UNITED STATES PATENT AND TRADEMARK OFFICE

Office Action Summary	Application No. 10/769,364	Applicant(s) VANDERHOEF, JOHN P.	
	Examiner William V. Gilbert	Art Unit 3635

DETAILED ACTION

Figure 9 from Stegner

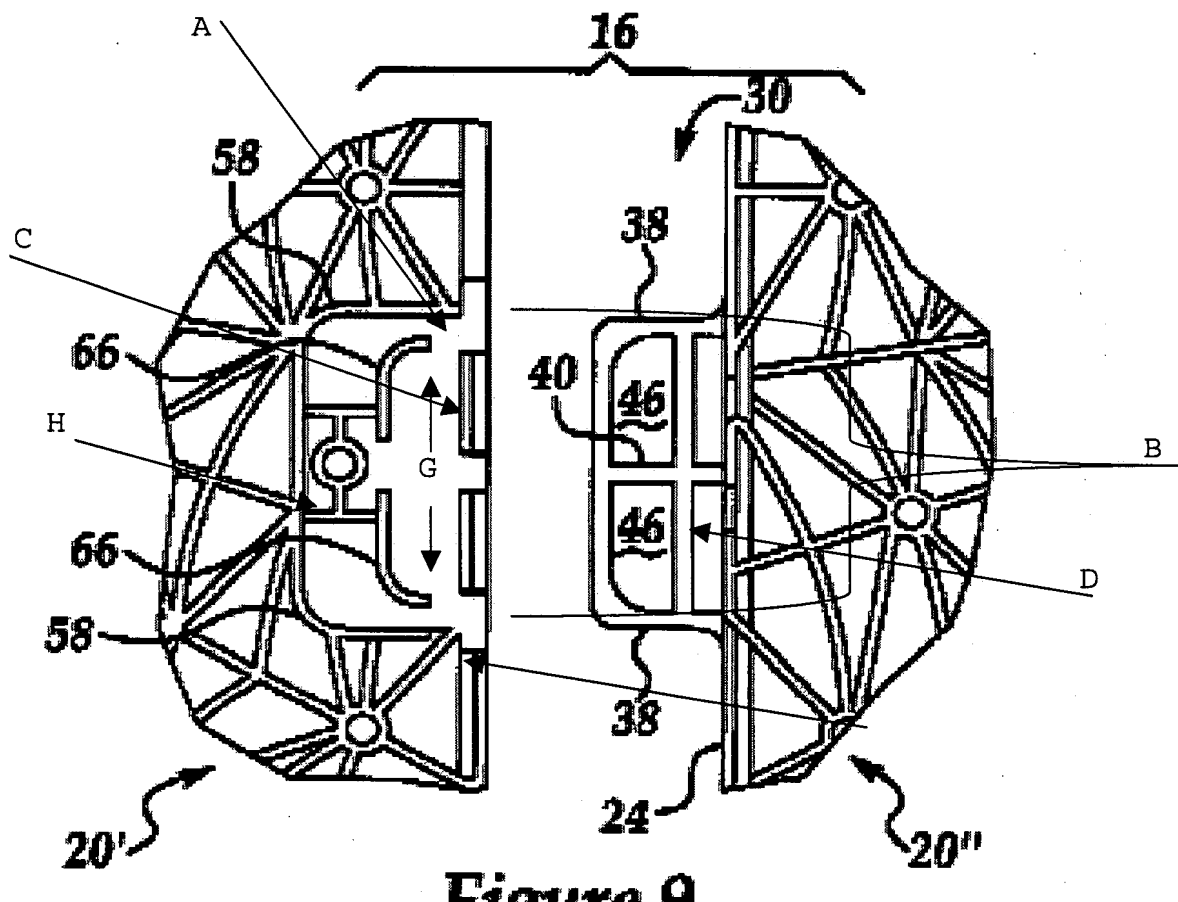
Claim 29: Stegner discloses a flat interlockable tile of substantially resilient material having a central portion (Fig. 3: 14) having top and bottom surfaces and elongated support edges (see "A" below) having a longitudinal inner edge (58) joined to the central portion, a free outer edge interlock structure ("B" below) on each support edge a series of first and second sets of adjacent male interlocks ("C" and "66" respectively below) formed with walls that project

perpendicularly from the support edges in longitudinally spaced apart relationship, the second set of interlocks has an elongated wall with inner and outer sidewalls (outer sidewall faces the first male interlock, "C") and extending longitudinally and transversely to provide a succession of second wall traversals of its corresponding support edge, the outer sidewall extends opposite a first male interlock ("C") of its corresponding interlock sets and the outer sidewall forms an open ended channel with the first male interlock and is sized to mate with an inverted second male interlock ("D" below) and the inner sidewall of the second male interlock provide an interior wall portion for an open-ended cavity to mate with an inverted first male interlock (46).

Claim 32: the channel has a pair of transversely diverging channel sections ("G" from Fig. 9 above) to form a continuous channel of U-cross sectional shape around part of the first male interlock

Claim 33: the outer sidewall of the second male interlock is curved whereby the traversal of the respective support edge has an alternating configuration in plan view (see outer

sidewalls from Fig. 9 above in relation to "G" above for alternating configuration.)

Claim 34: the wall of the second male interlock has a projecting rib ("H" from Fig. 9 above) of substantially rectangular cross section and the inner and outer sidewalls are formed on the rib in substantially parallel relationship one to another.

Figure 2 from Stegner

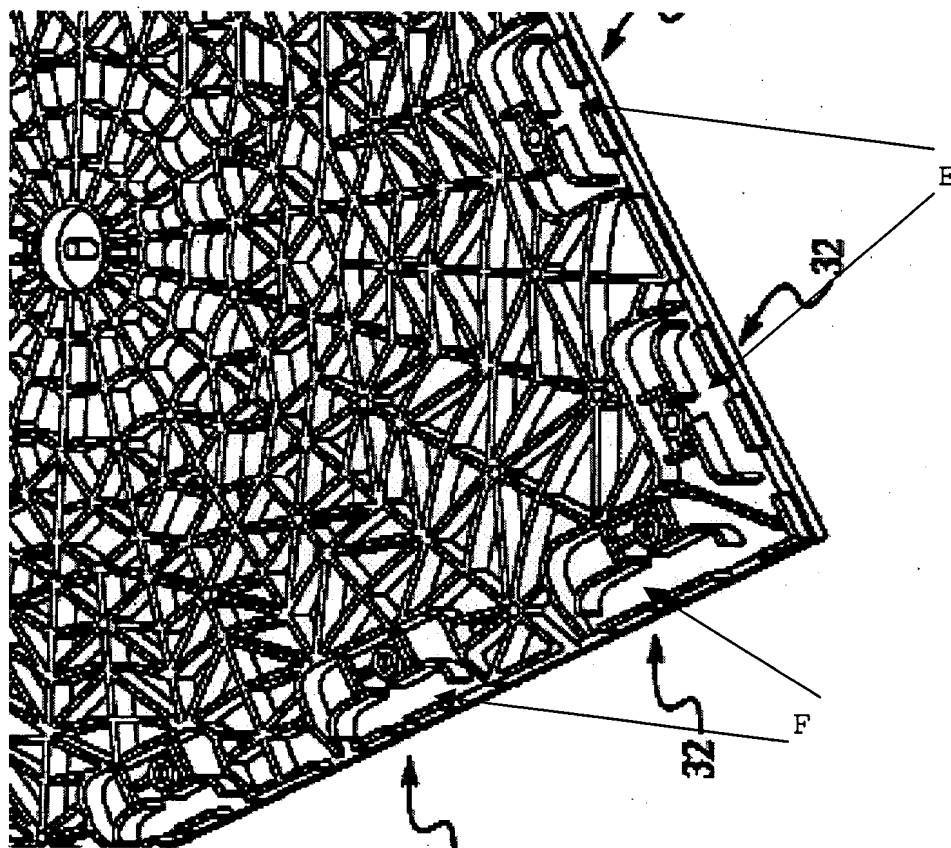
Claim 31: the tile is quadrilateral shaped with two pairs of support edges (see "E" and "F" below) and the layer is a decorative covering (any layer can be used as decorative) that covers the top surface of the central portion and one of the pairs of support edges.

Figure 7 from Stegner

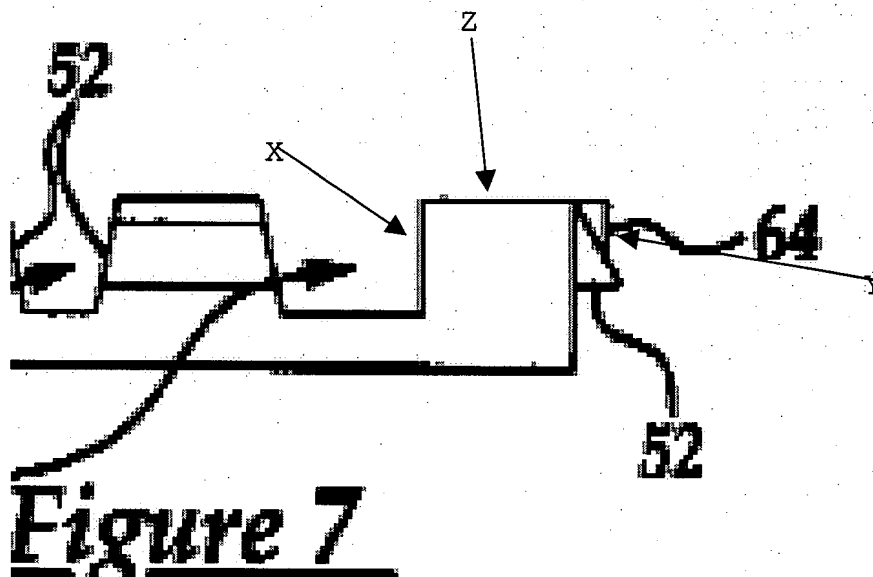
Claim 35: the male interlock of a first set comprises a multisided lug (52) having a planar free end surface parallel to the plane of the central portion of the tile (see indication of "52" from Fig. 7).

Claim 45: certain ones of said first walled structures ("C" above) have three adjoining sides (see "X", "Y" and "Z" below), two of the sides are opposite one another ("X" and "Y") and joining opposite respective ends of a third side ("Z")

Second Figure 9 from Stegner

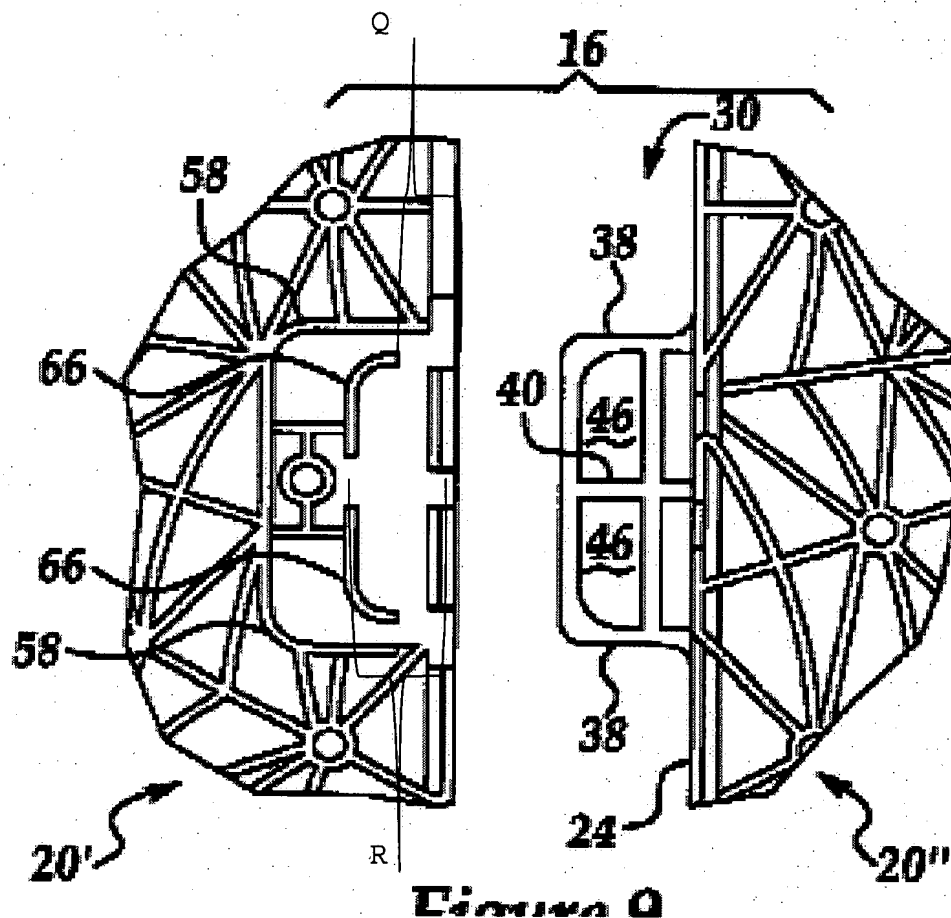
Claim 55: a first open sided channel ("Q" below) traverses along the edge between adjacent ones of the first interlock elements and a second open channel ("R" below) traverses between the second interlock elements, the second channel having a greater width than the first channel.
